# THE VILLAS AT CLAREMONT RANCH

## CONSTRUCTION DRAWINGS

### STREET IMPROVEMENTS PLANS

## STORM SEWER PLANS

THE VILLAS AT CLAREMONT RANCH		SCALE: 1" = 50'	DATE: 01/17/20
STORM SEWER PLAN & PROFILES		JOB NUMBER: 16-102	SHEET: 3 OF 4
DRAWN BY: MGP

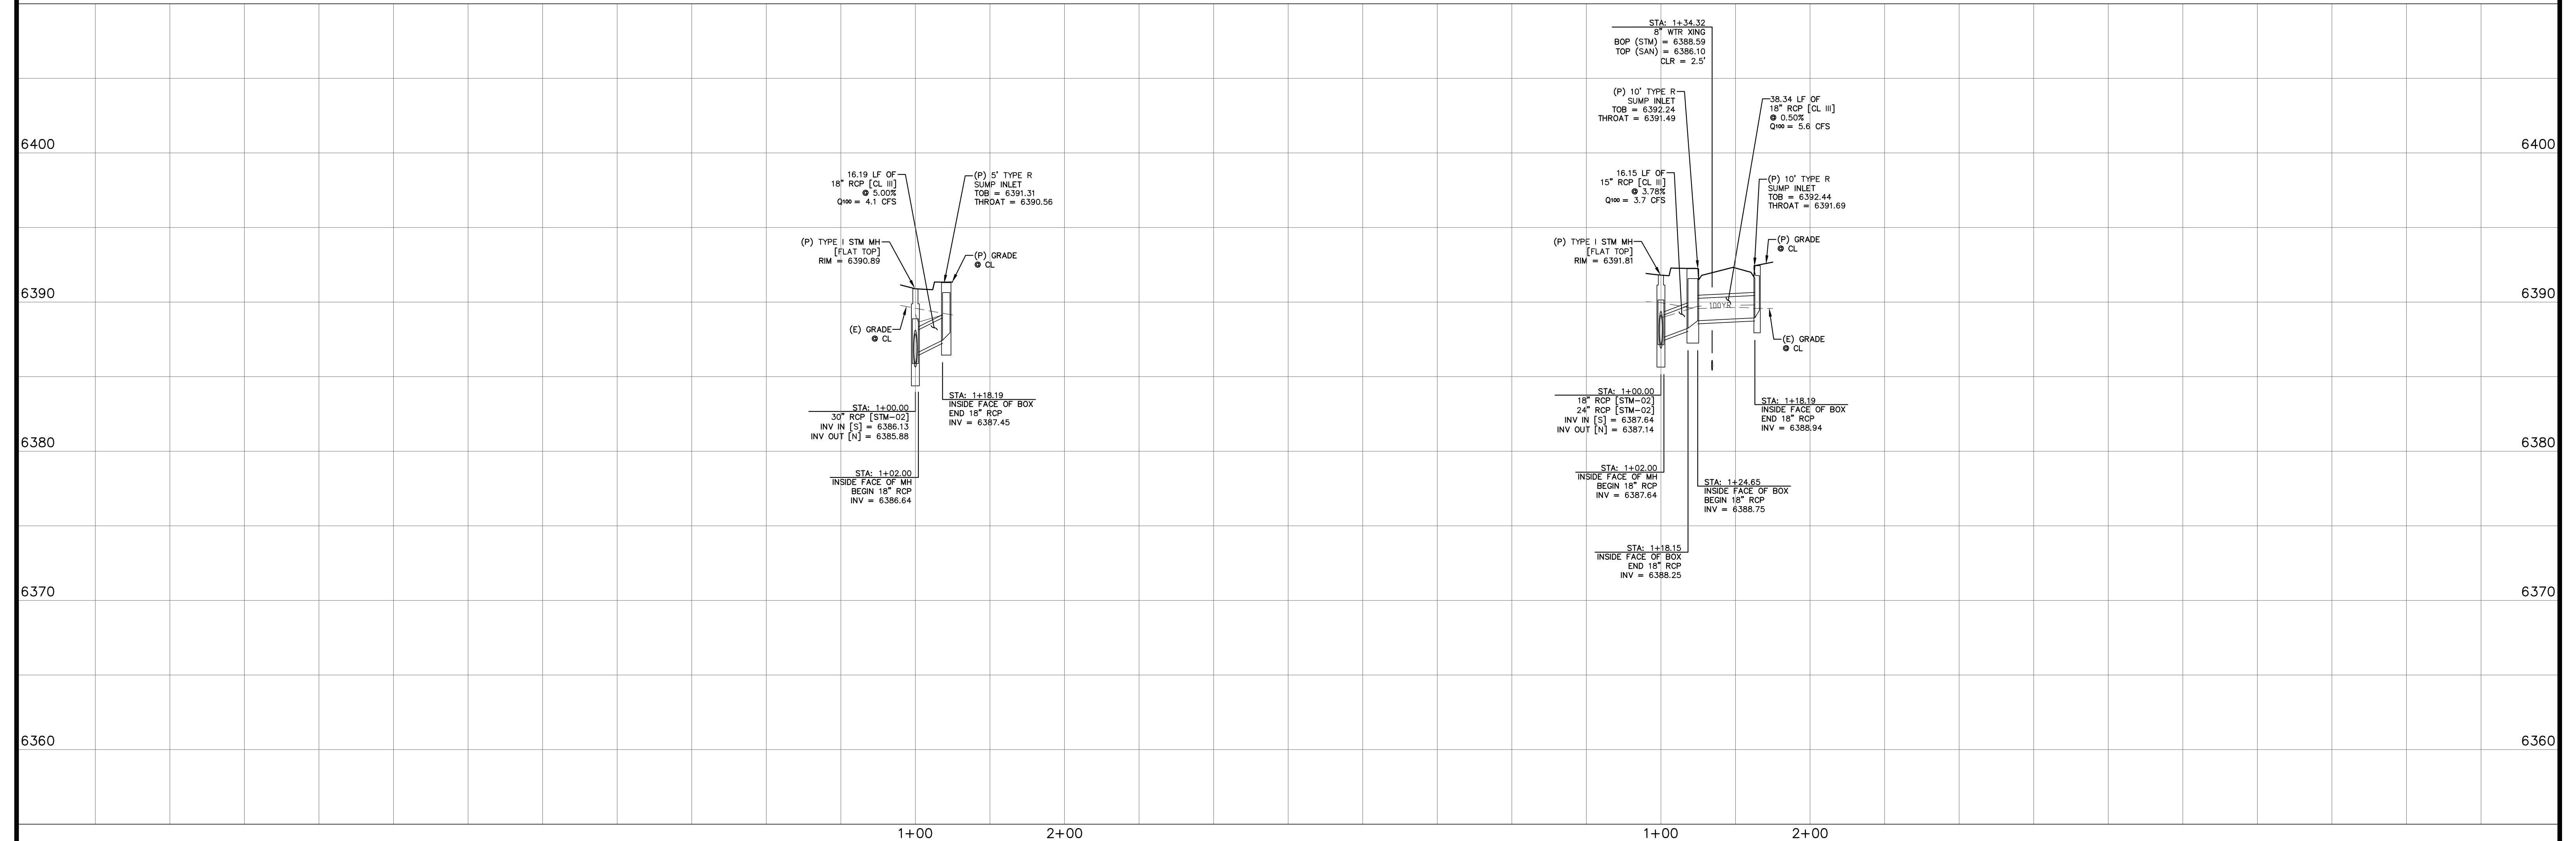
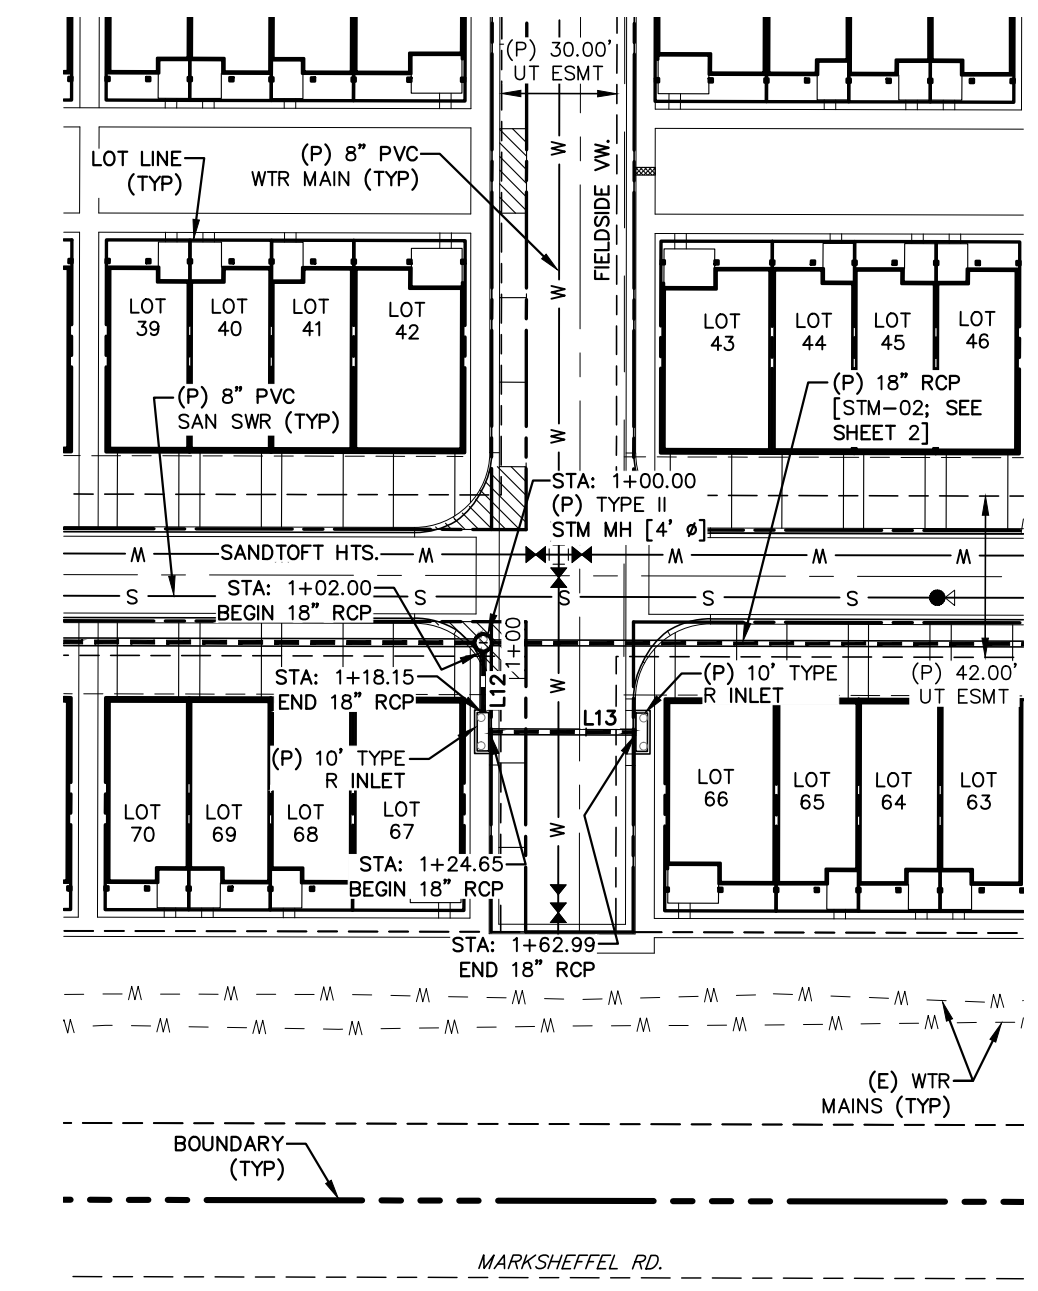
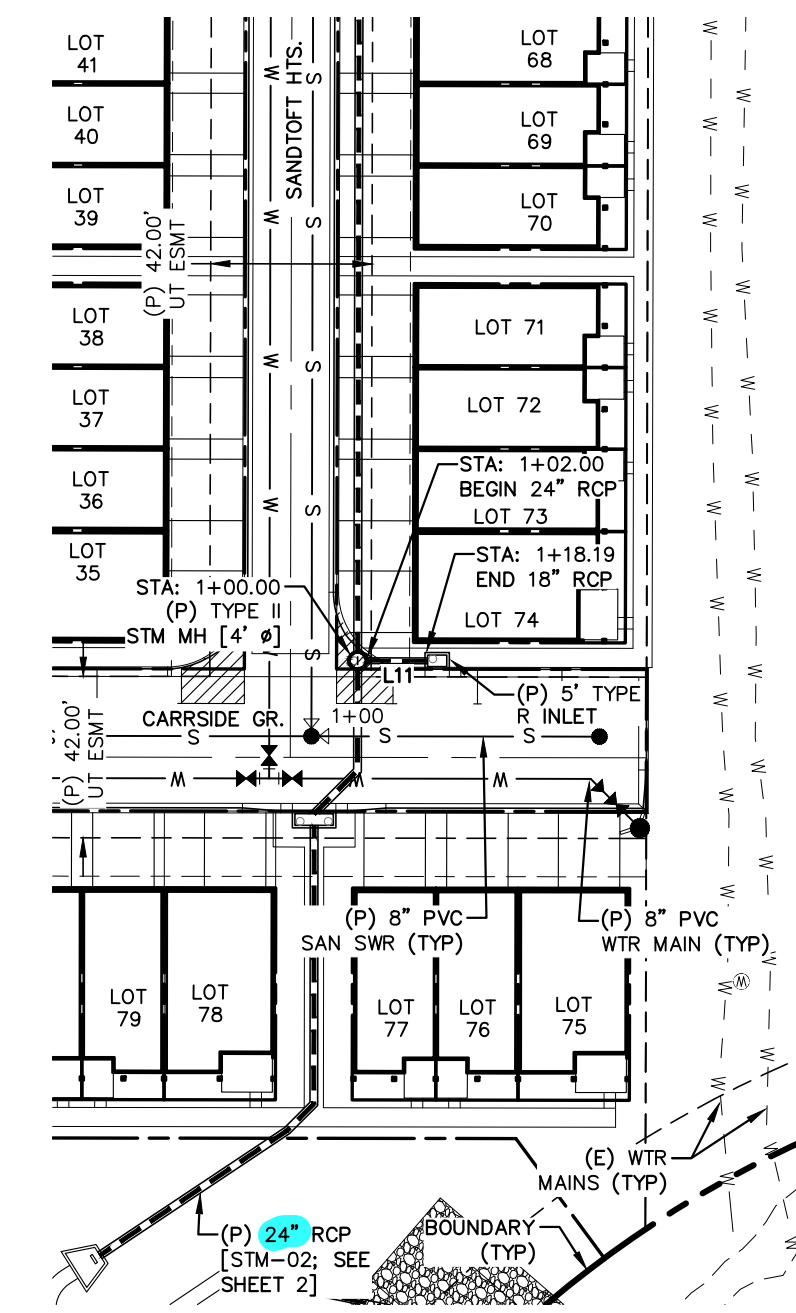
Provide storm details for manholes, inlets, riprap outlet protection
